# Memo

Project No. 0983A

**Re: Silvercreek Solar Park Natural Heritage Assessment Addendum**

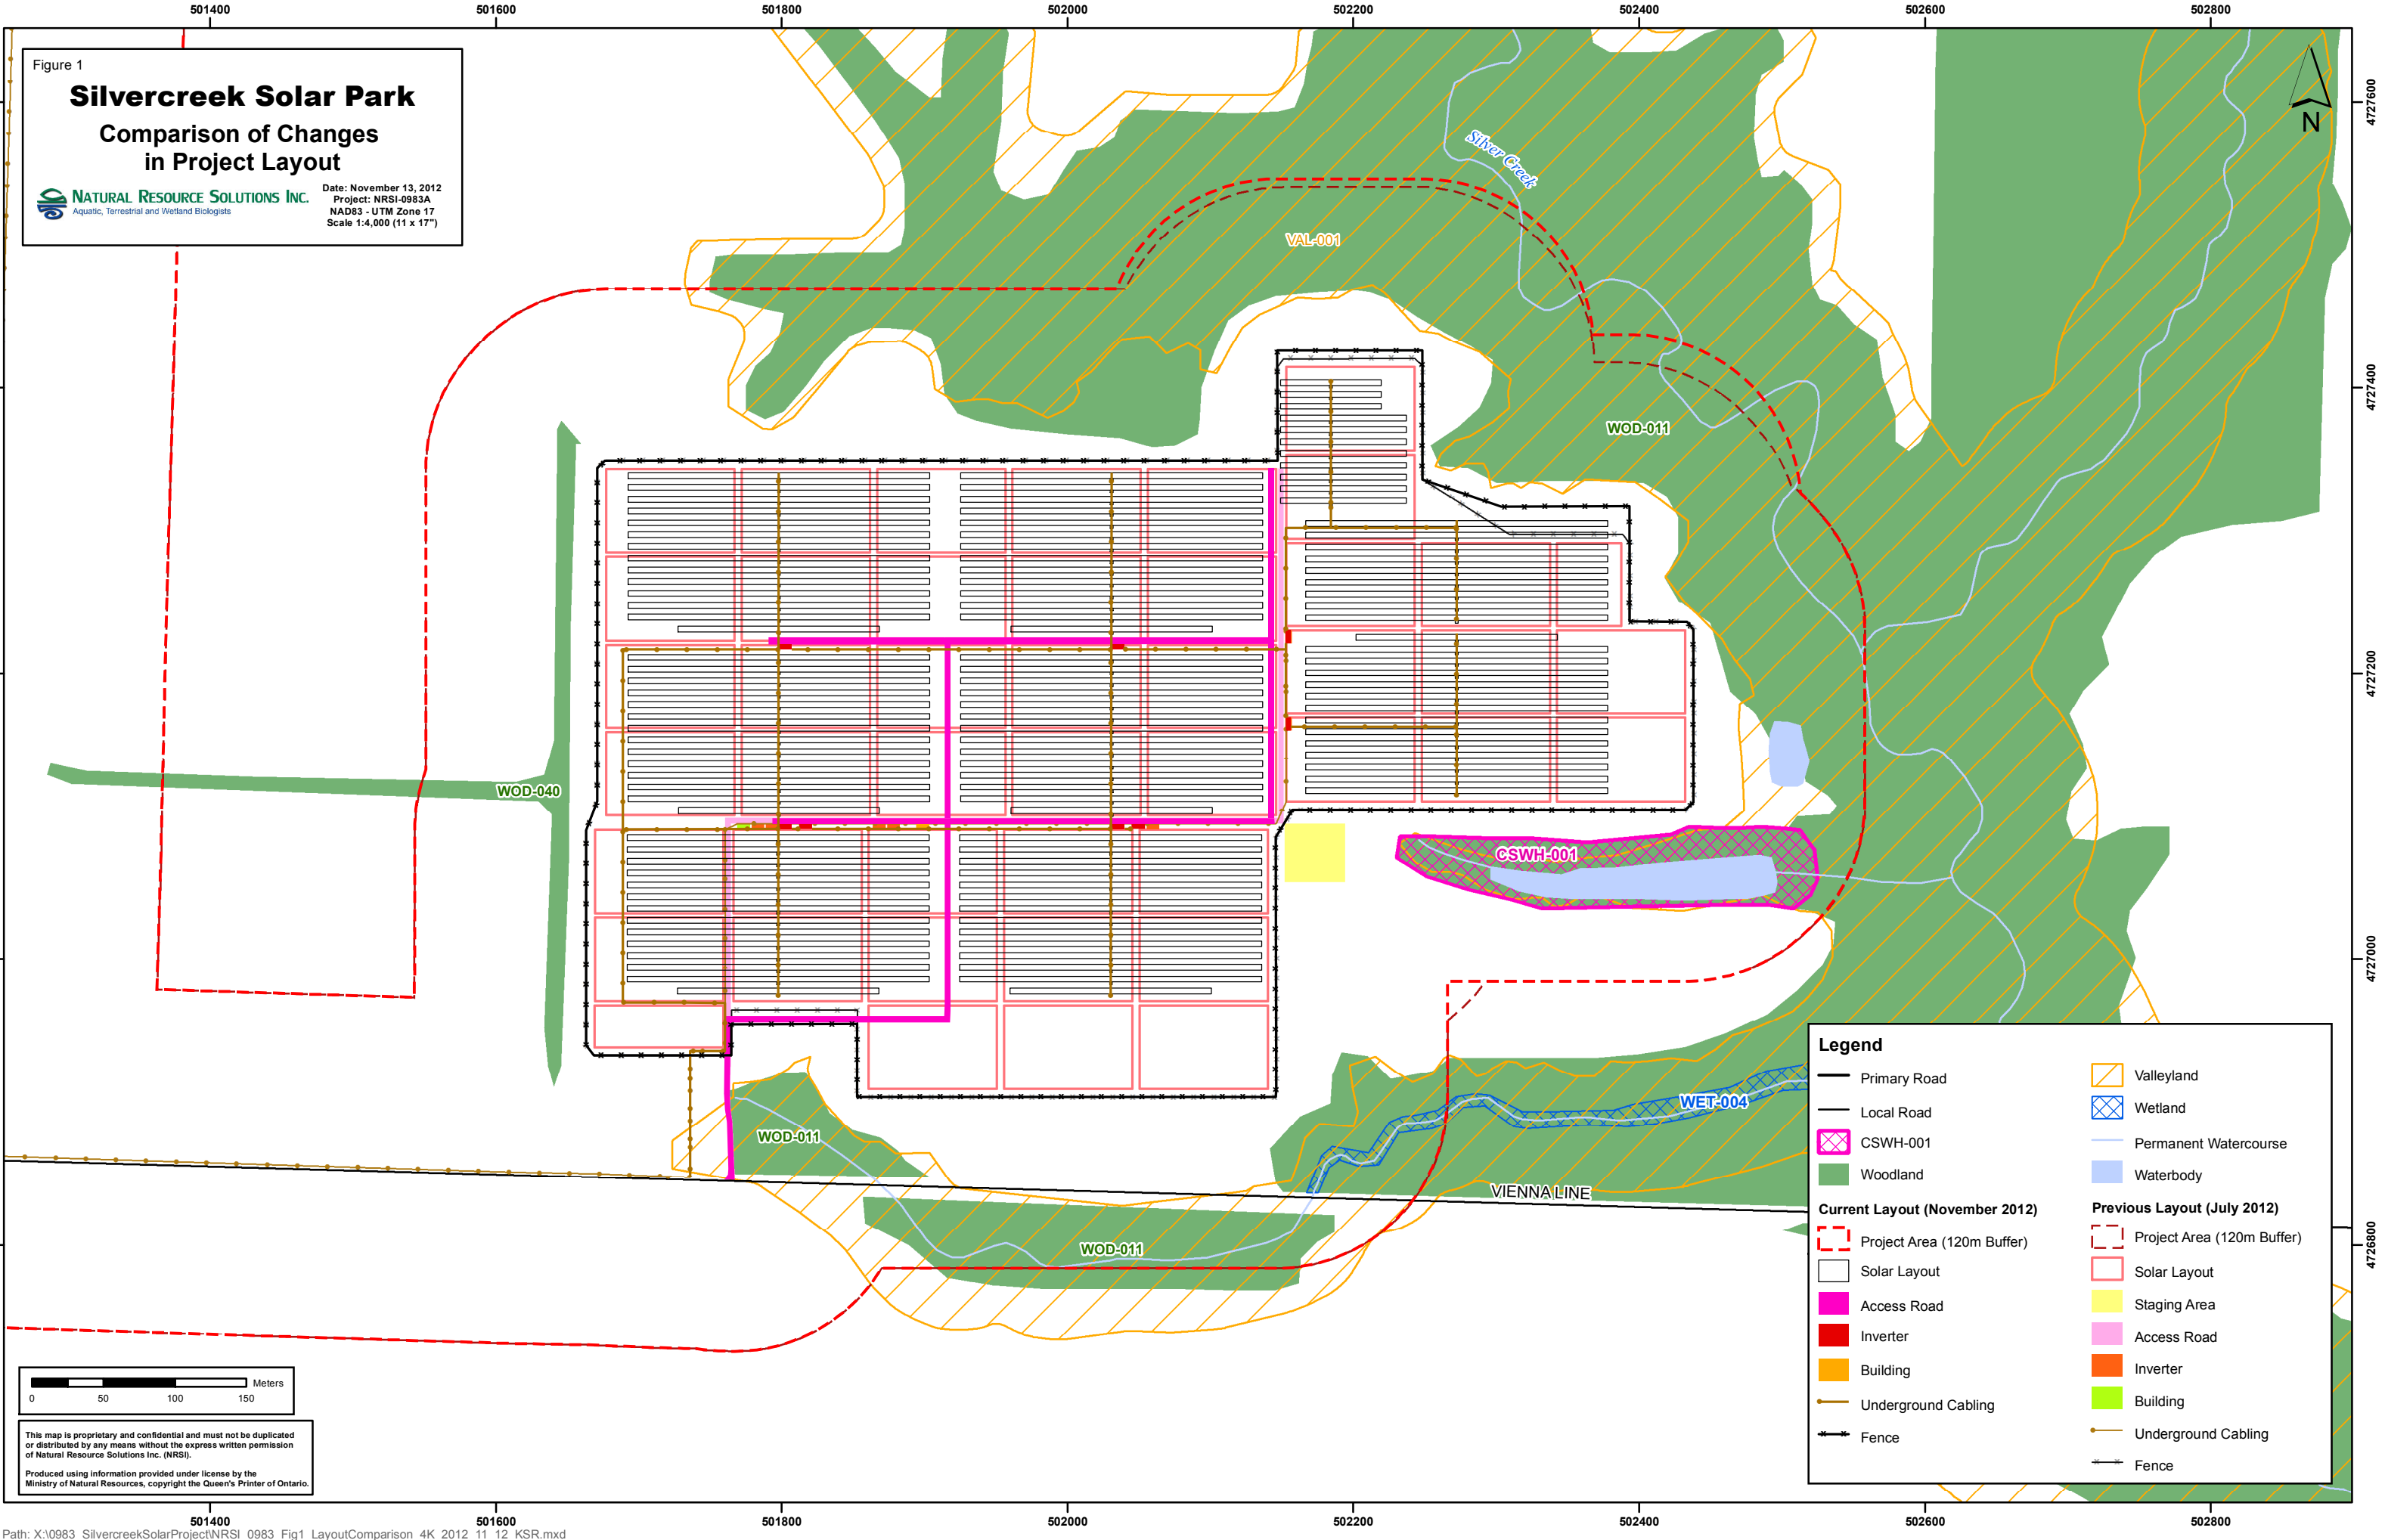
This document identifies and discusses minor layout changes that have been made to the Silvercreek Solar Park project location since receiving the NHA confirmation from the MNR, but before the ultimate REA submission to the MOE. The updated project layout addressed in this report is provided in Figure 1, which compares the updated project components to those presented in the NHA.

- Distances from project components to natural features
- Access road layout modifications in the solar park area
- Solar panel mounting system and layout
- Perimeter fence, inverter, and underground cabling layout modifications to accommodate changes in solar panel layout
- Removal of the temporary laydown area at the solar park

The changes to the Silvercreek Solar Park project layout are very minor, with minimal changes to the overall project area. These changes are outlined and discussed in Tables 1 and 2. Figure 1 provides a visual overlay of the differences between the NHA submission layout and the layout presented in this addendum. The Silvercreek Solar Park project layout presented in the original NHA submission is provided for reference in Appendix II.

Project Component	Location	Description/ Rationale of Change	Changes in Distance to Natural Features or New Natural Features Within 120m	Reference Figure(s)
Solar Panel	Solar Park Area	The solar panel mounting system being used for this project has changed from a tracking model to a fixed-tilt model. Solar panel layout has changed slightly as a result.	The change in solar panel arrangement results in solar panels being closer to VAL-001 and CAAP-001, however, this is not the closest project component to these features. Solar panels are now further from WOD-011, WOD-040, and WET-004. No new natural features are included in the project area as a result of this change.	1
Perimeter Fence	Solar Park Area	The perimeter fence has shifted slightly to accommodate the change in solar panel layout.	This change in footprint shape does not result in the perimeter fence being closer to or further from any natural features. No new natural features are included in the project area as a result of this change.	1

Access Road	Solar Park Area	The access road layout has been modified to accommodate requests from the Municipality.	This adjustment results in small changes in the distances between the project location and natural features. It is now slightly closer to WOD-040, however, this is not the closest project component to this feature. The access road is now also further from CAAP-001. No new features or habitats are included in the project area as a result of this change.	1
Inverters	Solar Park Area	The locations of inverters have shifted slightly to accommodate the change in solar panel type and layout.	This adjustment results in small changes in the distances between the project location and natural features. Inverters are now closer to VAL-001 and CAAP-001, however, they are not the closest project component to these features. Inverters are now also further from WOD-011. No	1

new natural features are included in the project area as a result of this change.	
Underground Cabling	Solar Park Area	The arrangement of underground cabling within the solar park area has shifted slightly to accommodate the change in solar panel layout.	This adjustment results in small changes in the distances between the project location and natural features. Underground cabling is now closer to CAAP-001, however it is not the closest project component to this natural feature. Underground cabling is now also further from WOD-011. No new natural features are included in the project area as a result of this change.	1
Laydown Area	Solar Park Area	The laydown area for construction within the solar park area has been removed.	This adjustment results in no changes in the distances between the project location and natural features. Previously, the perimeter fence was closer to natural features than the laydown area, and this will still be the case with the laydown area removed. No new natural features are included in the project area as a result of this change.	1
